PROJECT NAME: MELODY PRESERVE

PROJECT NUMBER: 2024100025

APPLICATION: IMPROVEMENT PLAN #32515

MARION COUNTY
SHEET NUMBER
C01.04

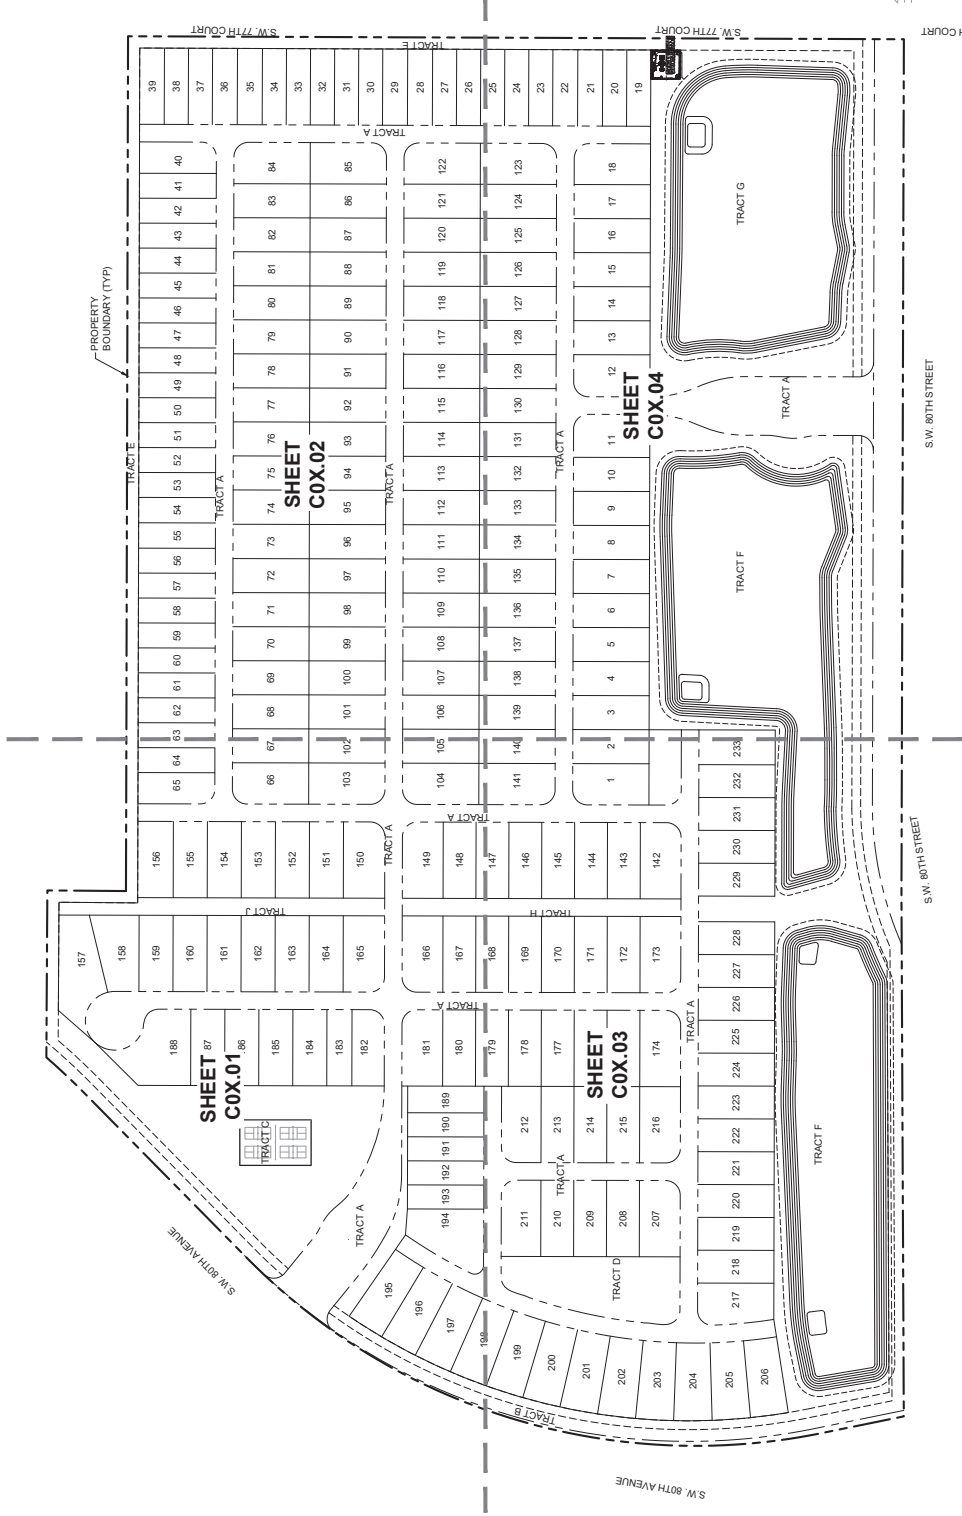
- 81 DEPARTMENT: 911 - 911 MANAGEMENT
REVIEW ITEM: 2.12.28 - Correct road names supplied
STATUS OF REVIEW: NO
REMARKS: I have labeled the road names on Sheet C01.04. Please label road names accordingly on all future submittals.
